CLEPA proposals for revision to TRANS/WP.29/GRSP/2001/13

Note: The text reproduced below was prepared by the experts from CLEPA in order to introduce revisions to the content of document TRANS/WP.29/GRSP/2001/13 covering proposals to introduce in Regulation No.44 a type approval scheme (flow chart), including product qualification and specifying the conformity of production.

PROPOSAL FOR DRAFT AMENDMENTS TO REGULATION No. 44
(Child restraints)

TYPE APPROVAL SCHEME (FLOW CHART ISO 9000:2000)

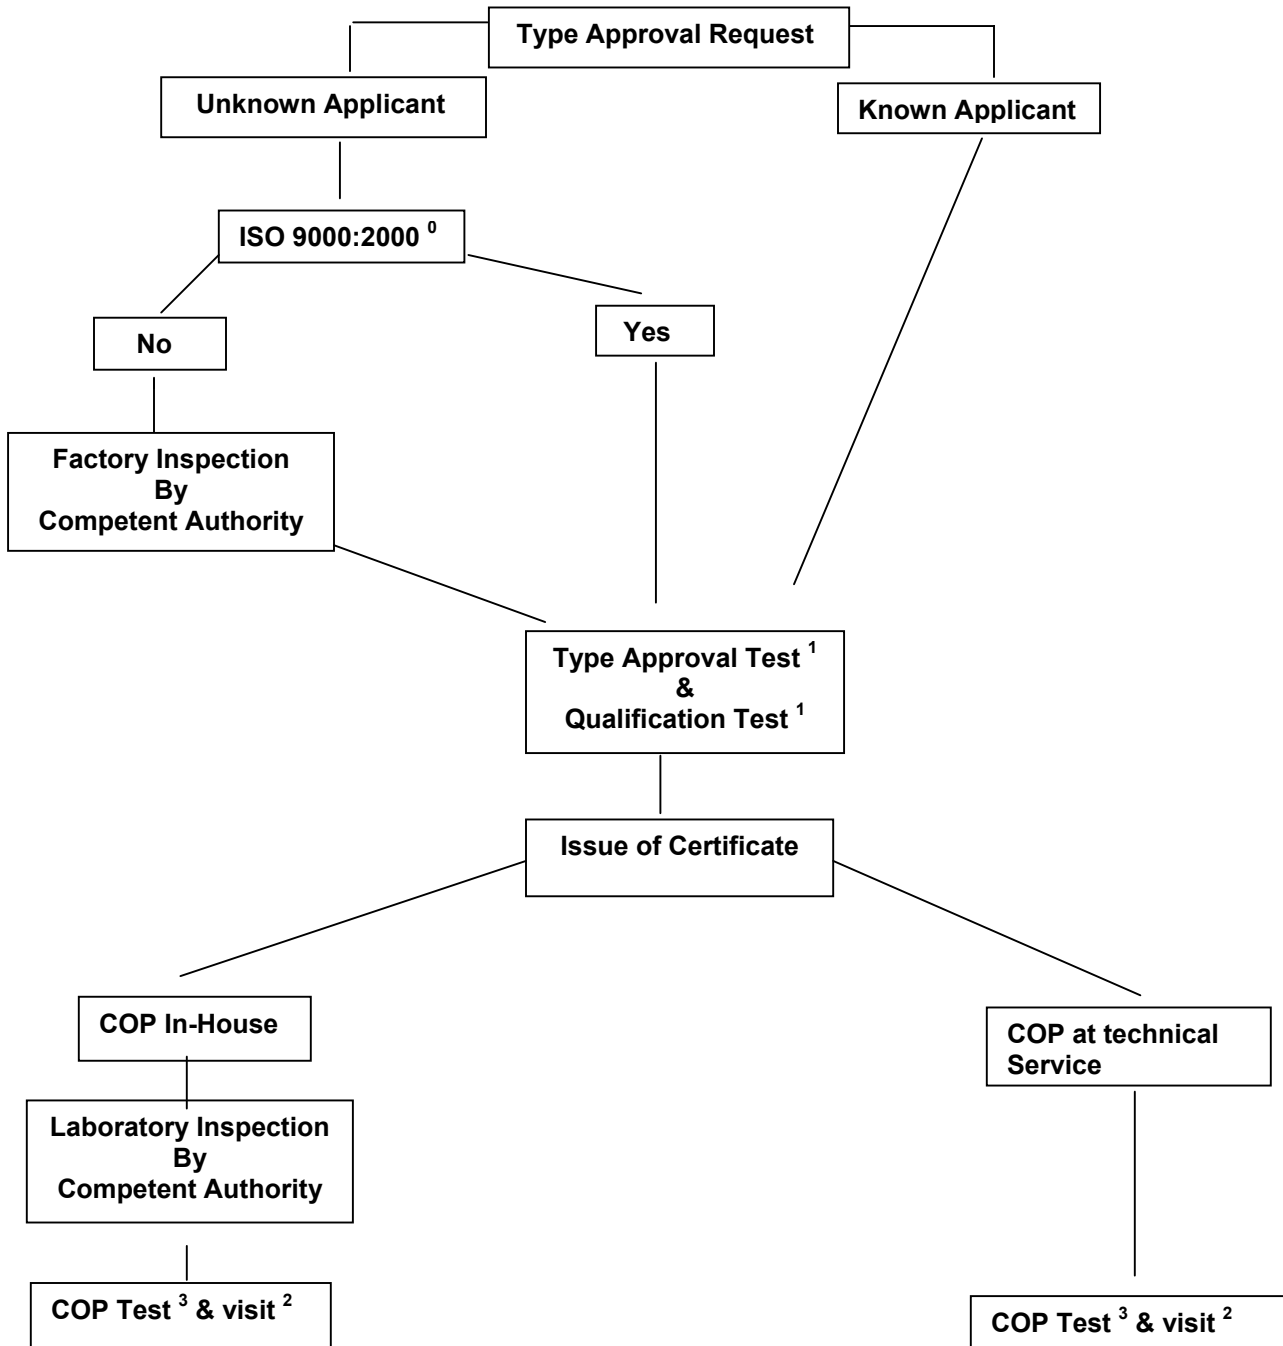
Insert a new annex 16, to read :

0) or an equivalent standard to this one

1) this test has to be witnessed by the technical service at an approved facility

- 2) visit to the manufacturer 2 times a year for inspection and random sampling by the Authority or technical service in accordance with 12.4**
- 3) tests in accordance with Annex 17 on samples selected by the manufacturer and submitted to their in-house laboratory or a technical service.**

Explanation of graphs relating to the CLEPA revised proposal for R44.03

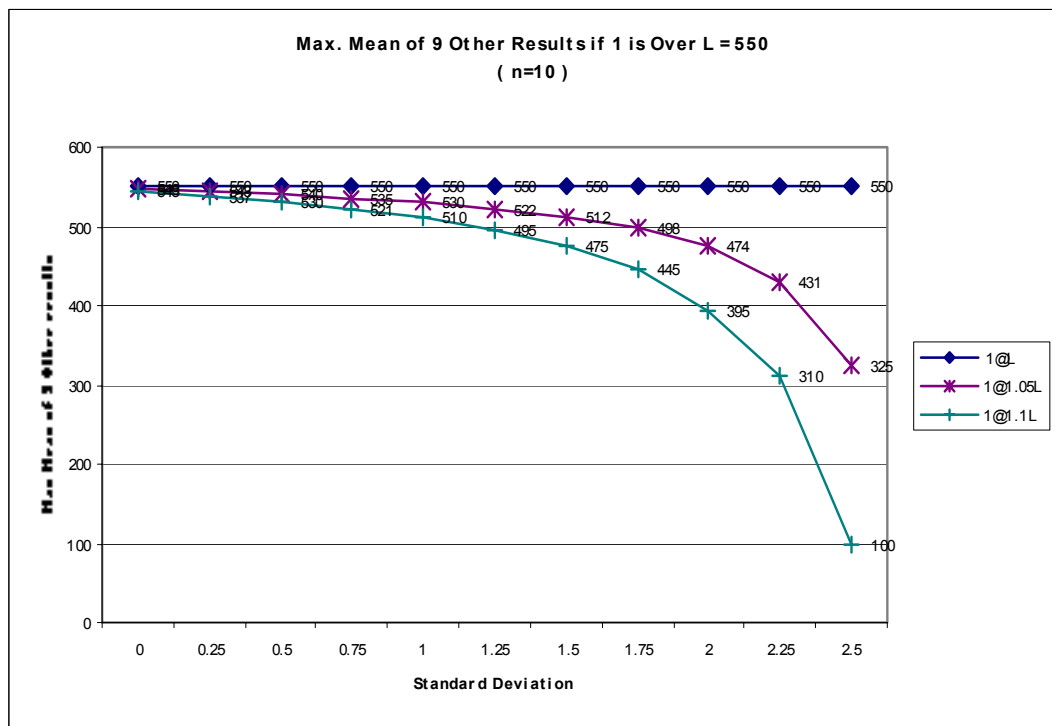
The graphs are to illustrate the apparent absence of logic in the original proposal for the acceptance criteria for the dynamic test for Production Qualification. ie:

No value shall exceed 1.1 L, and $X + 2.4S$ shall not exceed L, where:

These graphs show, for either (n=) 10 or 5 samples, what would happen if one of the results for head forward movement exceeded the limit (ie: L=550mm).

For one result exceeding L, We calculated what the mean (X) of the remaining results would have to be to achieve the standard deviation requirement ($X+2.4S$) for various values of S.

All this is to illustrate that that, although the proposal is to allow results in excess of L, the other constraint implies that the remaining results would have to be unrealistically low to compensate – this in practice is unrealistic, hence we believe the logic may be flawed.

The proposal would be to reduce the allowable excess from 1.1L to 1.05L (ie: from 605mm to 577.5mm if we are considering head movement) and require the mean of all results to be less than L. It is also felt that 10 samples is excessive and recommend 5.

This is illustrated by the following graph by the line Std Dev =0 and it can be seen that if the one result that exceeds L is 1.05L (ie: 577.5mm), the mean of the other 4 results must be greater or equal to 543.5mm.
